**Brooks County High School and Junior High
Field House Plumbing Upgrades.**

ADDENDUM NO. 1

ADDENDUM NO. 1

DATE: July 02, 2025
Project: Falfurrias HS and JrH Fieldhouse Plumbing Upgrades
Project #: 25v51
To: David Monreal, GMS

01 GYM BUILDING - NORTH
PLUMBING DEMOLITION AND RENOVATION PLAN
SCALE: 1/8" = 1'-0"

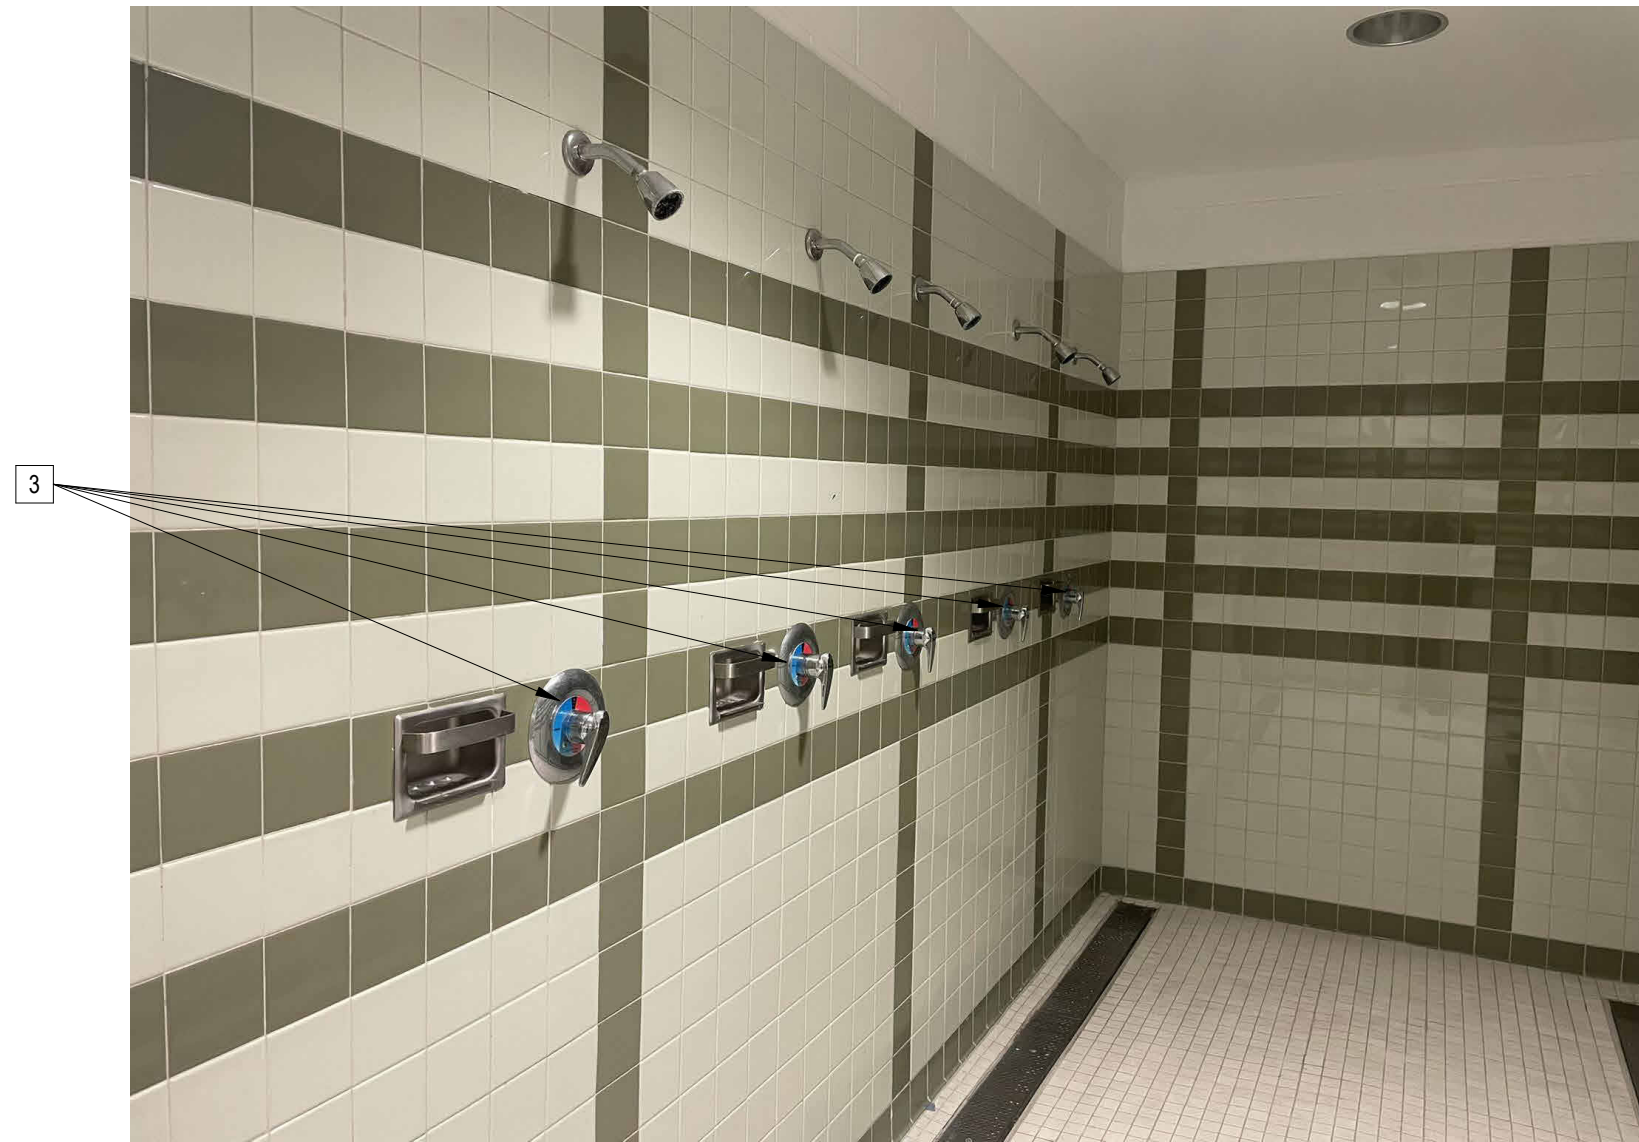
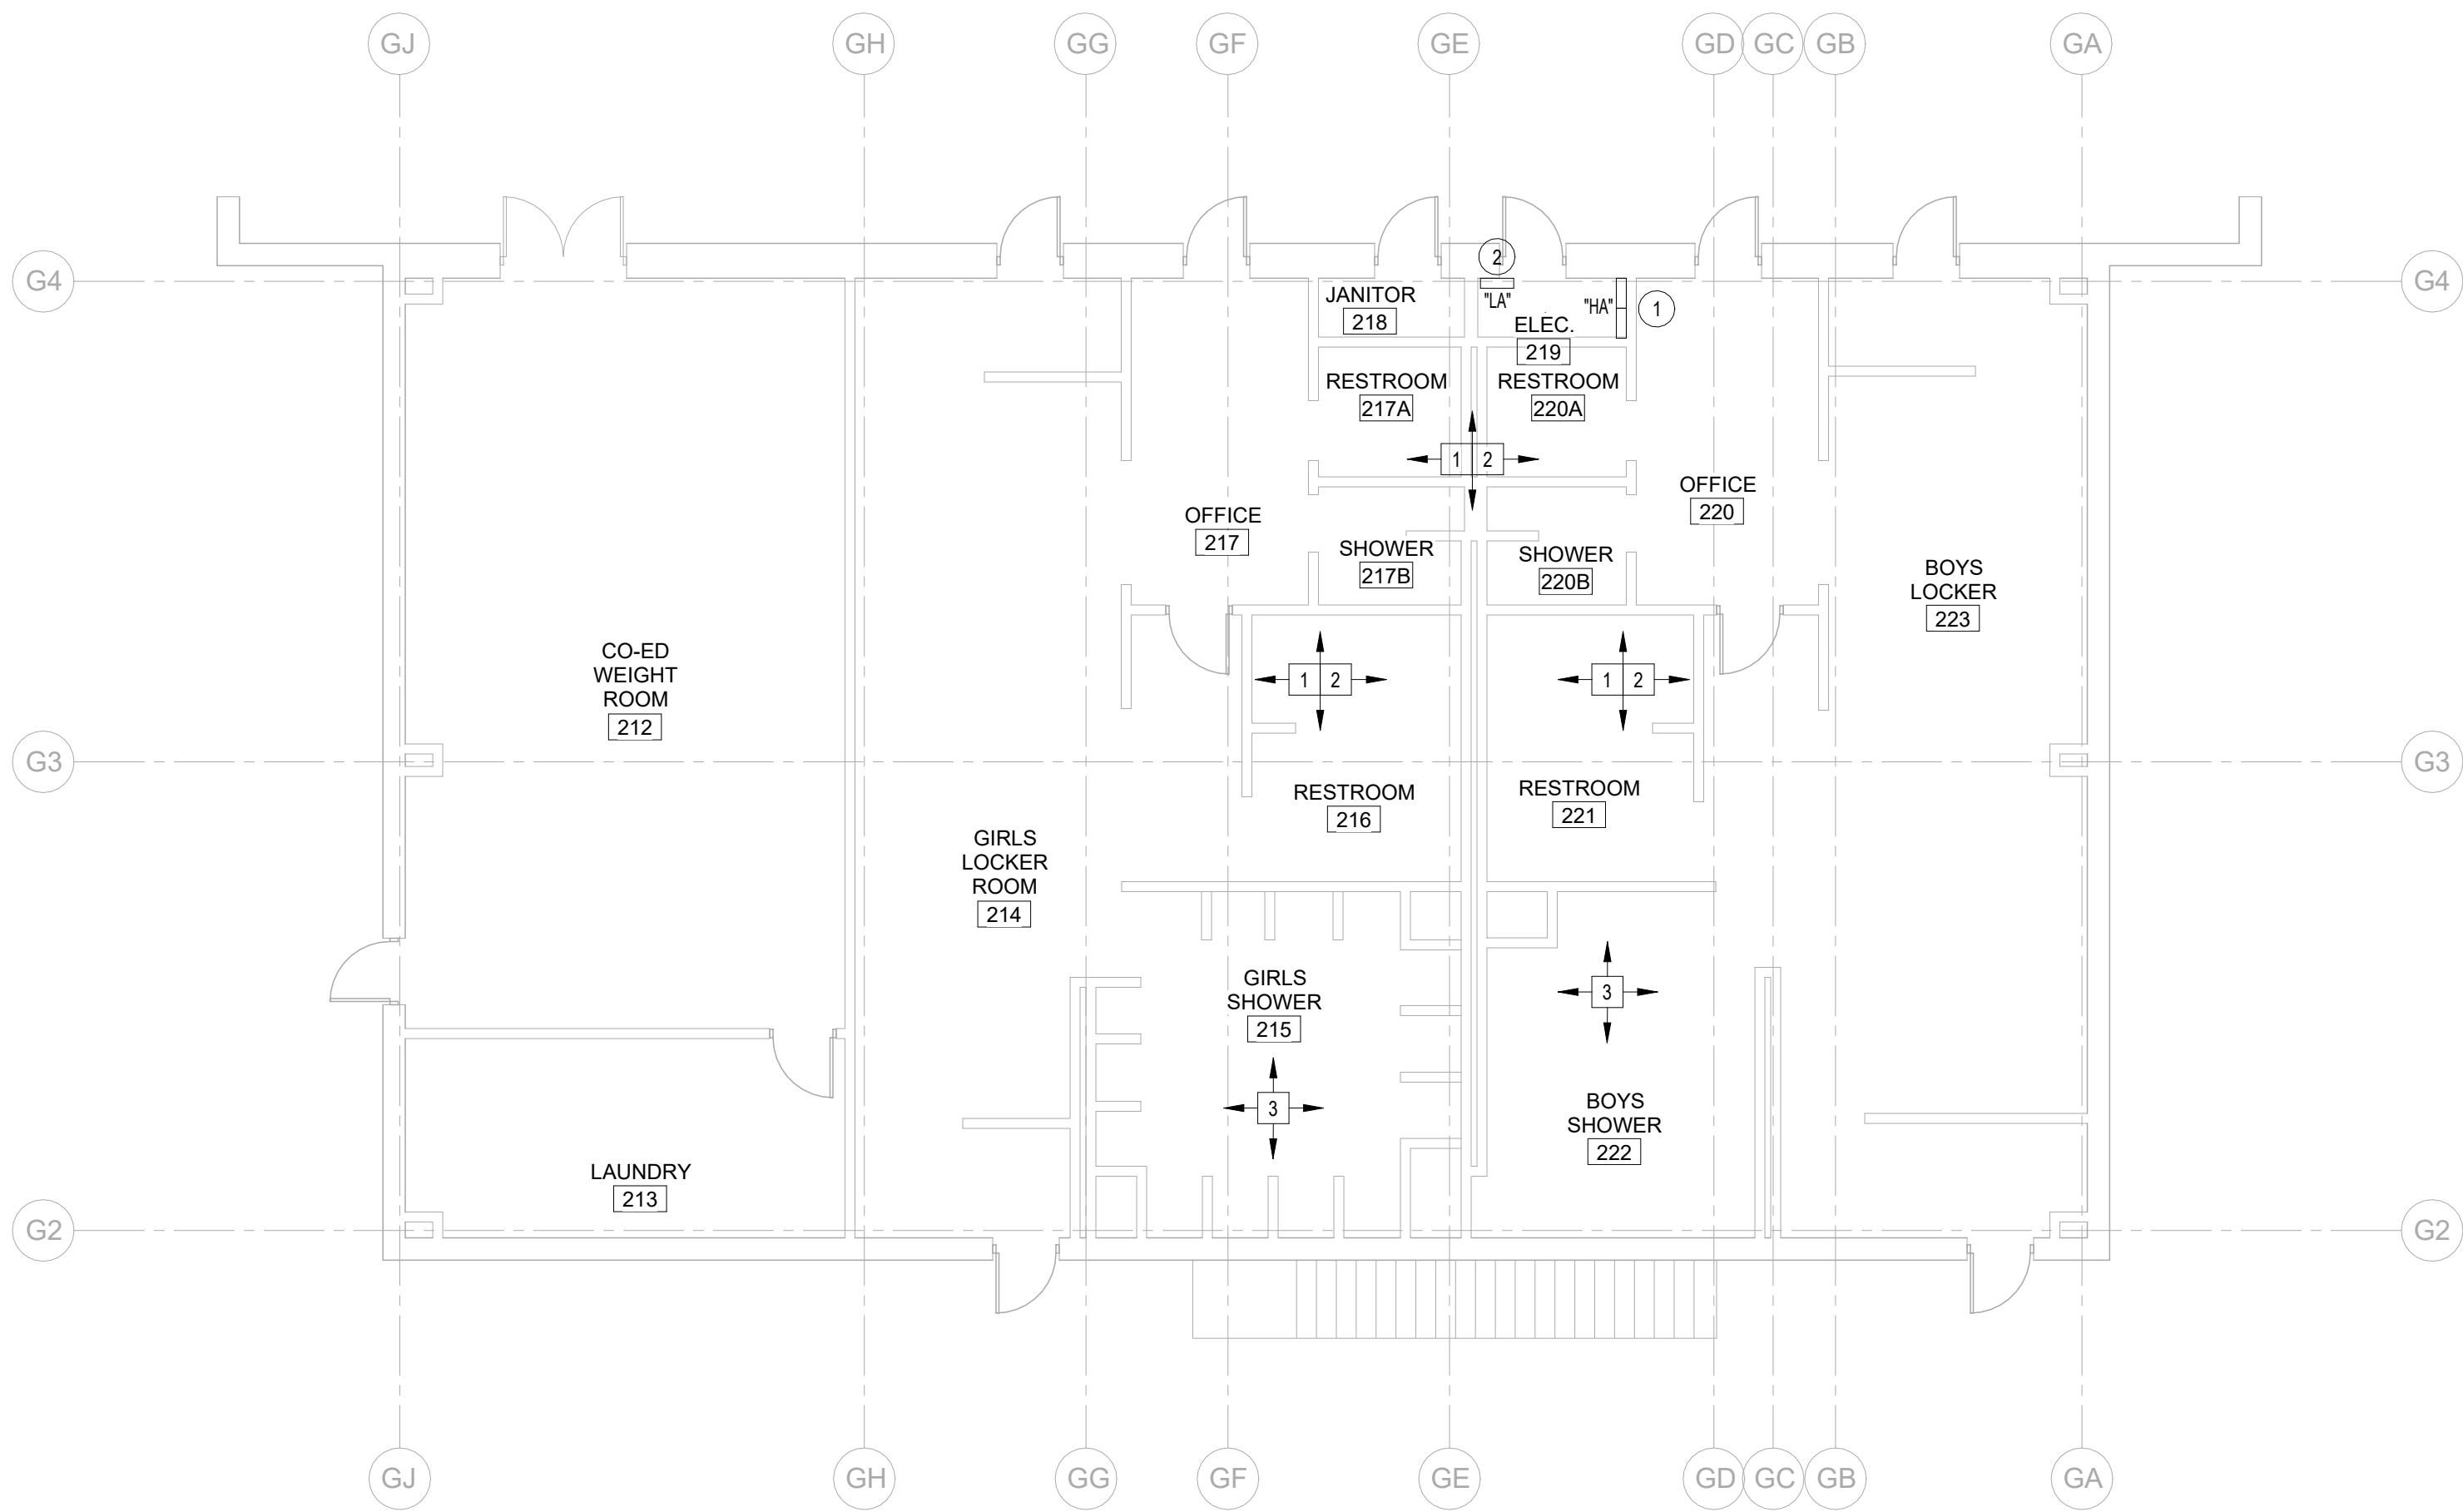
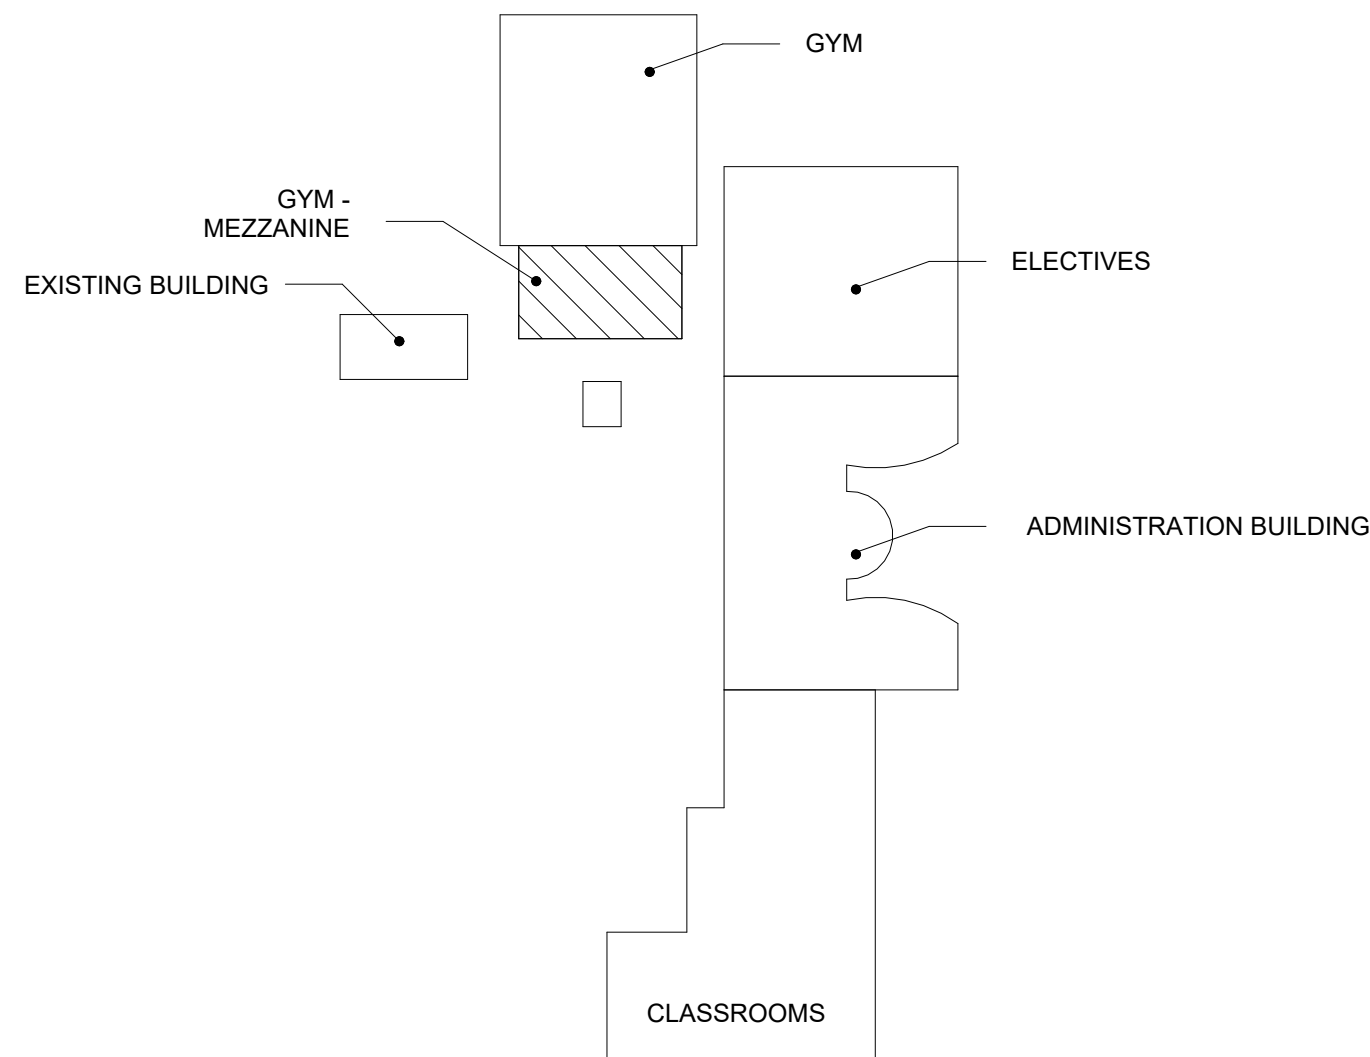
1. Sheet DEP2.01:
 - a) Revised Electrical and Plumbing Demolition Plan. See attached sheet.
2. Sheet DEP2.02:
 - a) Revised Electrical and Plumbing Demolition and Renovation Plan. See attached sheet.
3. Sheet EP3.01:
 - a) Revised Electrical and Plumbing Renovation Plan. See attached sheet.
4. Sheet EP4.01:
 - a) Revised Electrical and Plumbing Schedules and Details. See attached sheet.
